Category <b>S</b>	<b>Repair Guidance</b>	Ref. No. R027/13A	Page 1 of 4
Coverage <input type="checkbox"/> Distributor only <input checked="" type="checkbox"/> Please inform your dealers		Date Issued April 4, 2013	
Please convey this information to your <input type="checkbox"/> Director <input checked="" type="checkbox"/> General Manager <input checked="" type="checkbox"/> Warranty Dept. <input checked="" type="checkbox"/> Parts Dept. <input checked="" type="checkbox"/> Training Dept. <input checked="" type="checkbox"/> Field Rep.		Date Revised June 18, 2013	
Applicable Model  CX-5 (KE)	Applicable Countries or Specifications  Worldwide

**REVISED**

**Revision Note: "DATE OF MODIFICATION" has been revised.**

## Subject: Rattle noise from front door window glass

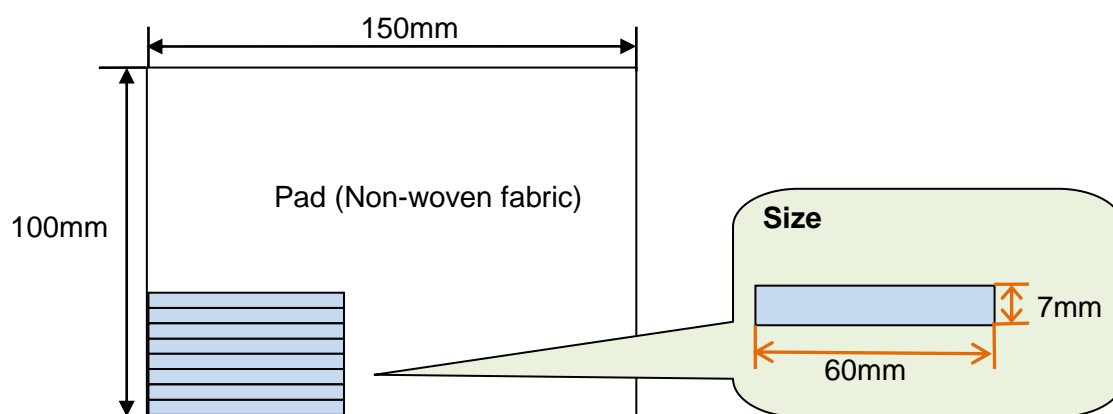
\* The following procedure shows right side glass run channel.

1. Open the door window glass fully.
2. Pull out the glass run channel from the door frame.

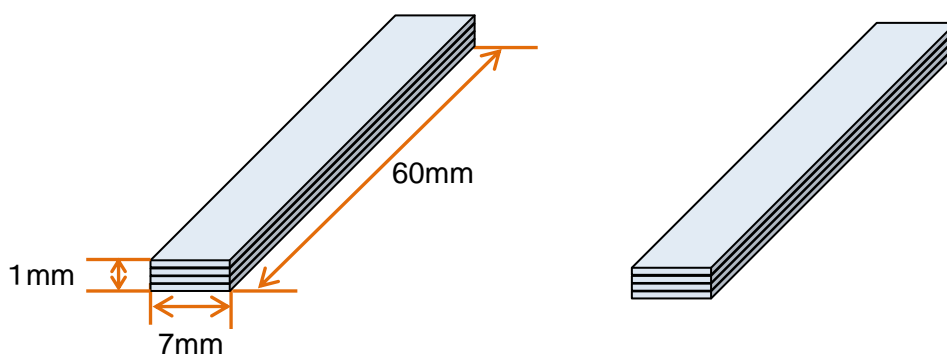
3. Select a sheet of pad in 0.25 mm thickness from the "Noise Parts Set" and cut it to the following size.

\* **8 pieces of 7 X 60 mm size. And prepare 2 sets of 4 pieces in layer.**

**(Prepare 2 sets of 4 pieces in layer.)**

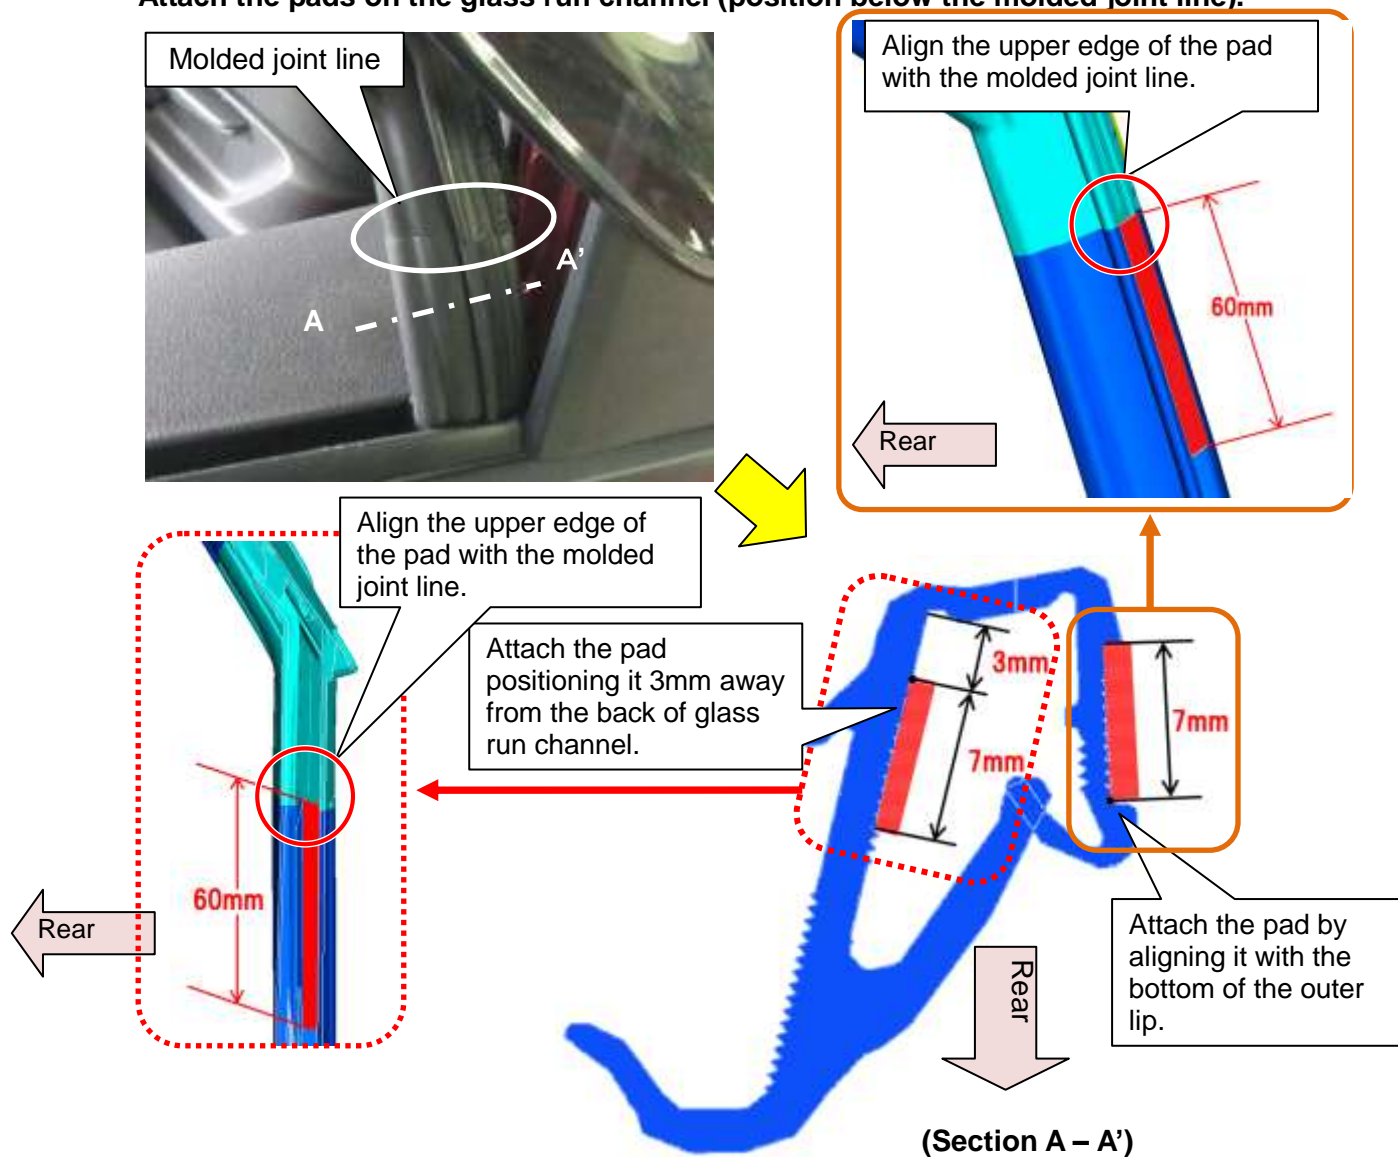
4. Degrease the glass run channel where the pads are applied (2 places) as shown below.

\* **Attach the pads on the glass run channel (position below the molded joint line).**
